# Hui Zhou Gaoshengda Technology Co., LTD

## Declaration of Differences in Tested Devices

We, Hui Zhou Gaoshengda Technology Co., LTD, declare on our sole responsibility for the product change of W7LM1110, W7LM1110A, for more details of change please refer to as below.

### 1. For W7LM1110

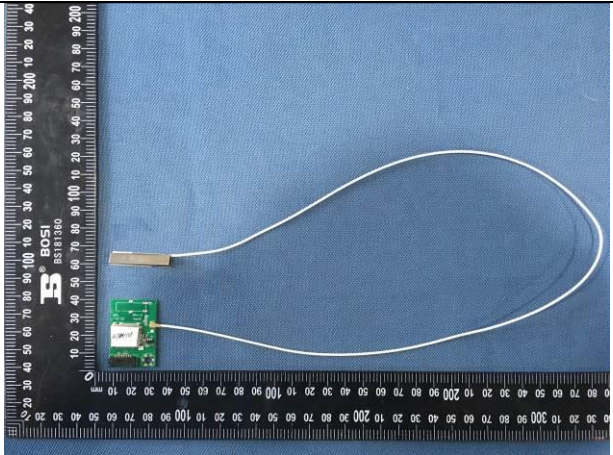
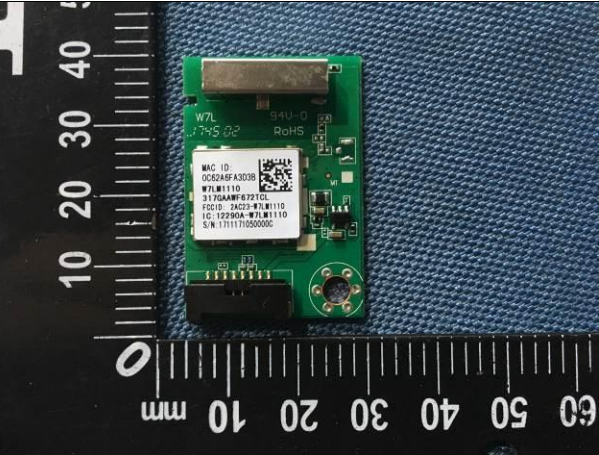
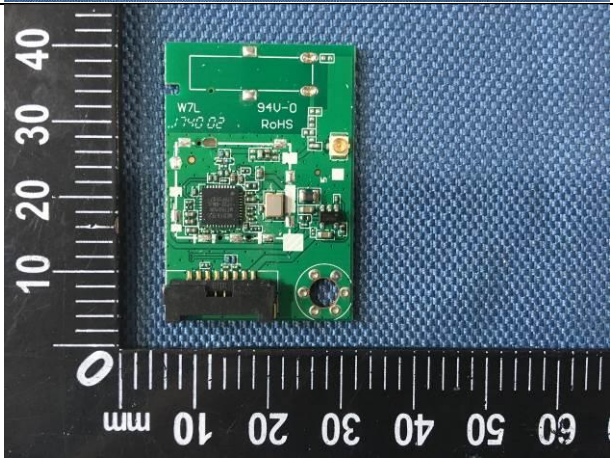
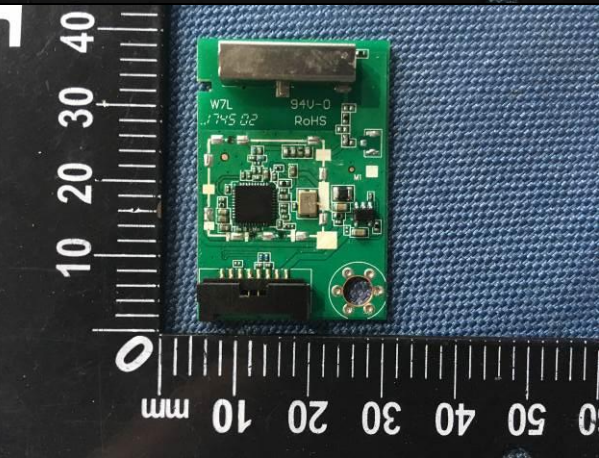
Old	New
N/A	<ol style="list-style-type: none"><li>1. Replace the new antenna (The antenna gain is changed from maximum 3dBi to maximum 1.88dBi).</li><li>2. Adding two 0 <math>\Omega</math> resistance</li><li>3. Add a RF test point.</li><li>4. Remove the white IPex</li></ol>

2. For W7LM1110A

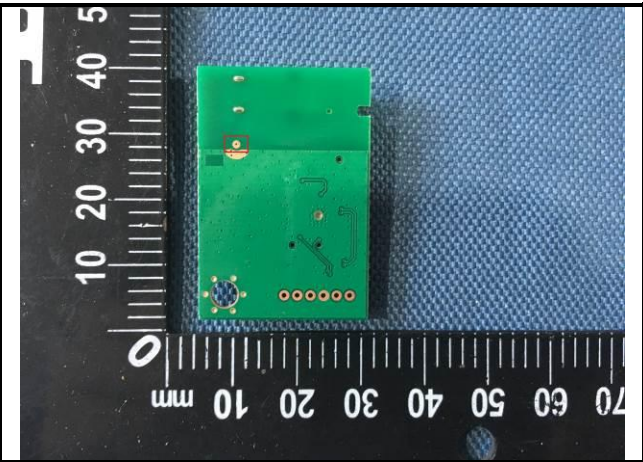
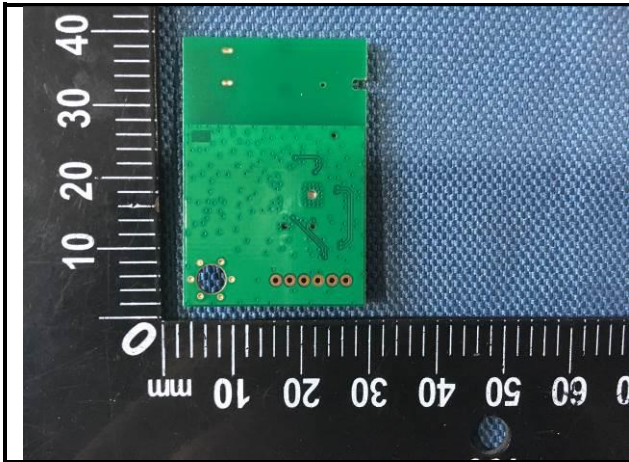
Old	New
<p>N/A</p>	<ol style="list-style-type: none"> <li>1. The antenna has not changed and the rf characteristics have not changed.</li> <li>2. The new Layout, IC and RF part has not changed</li> <li>3. Add two solder joints to the top.</li> <li>4. RF changes ground capacitance encapsulation.</li> <li>5. Power supply circuit modified 3.3V power supply, reserved 5V power supply.</li> <li>6. Power supply &amp; IO interface change.</li> </ol>
